Clonburris SDZ, Reg ref: SDZ22A0010  
Dublin 22

Ronan Mac Diarmada & Associates

## COMPLIANCE RESPONSE

July 2023

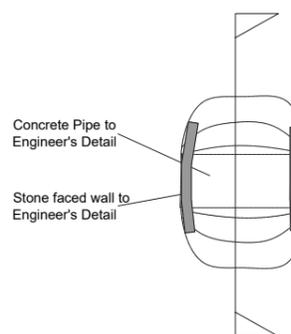
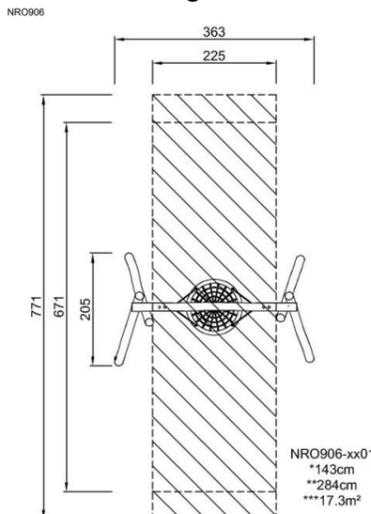
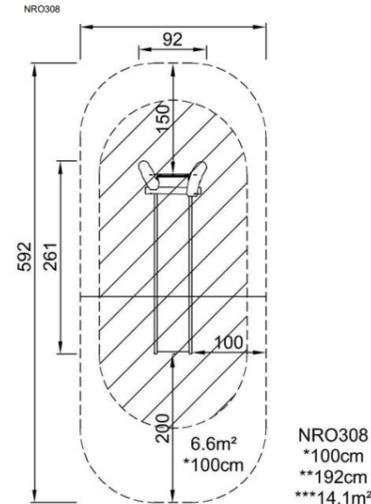
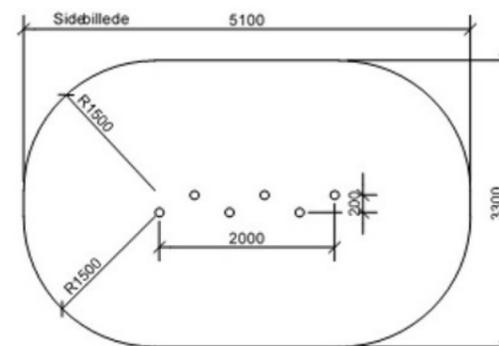
(iv) Revised play design at central open space

(v) Open space areas along all roads to incorporate natural Suds for attenuation, water treatment, amenity and biodiversity purposes as outlined in SDZ. Details of all natural SuDS features including swales, rain gardens, bioretention tree pits, channel rills, filter strips, ponds, detention basins with lower areas allowed to fill first (low flow channels), wetlands etc. to be agreed with Public Realm

(iv) The central open space has been revised to incorporate SuDS elements as well as revised play items. (Part of Phase K2, subject to change)

(v) Open space areas along all roads incorporate natural Suds for attenuation, water treatment, amenity and biodiversity purposes as outlined in SDZ. Please refer to details shown for treatment of swales and detention basin as per coordination with Engineer. (Part of Phase K2, subject to change)
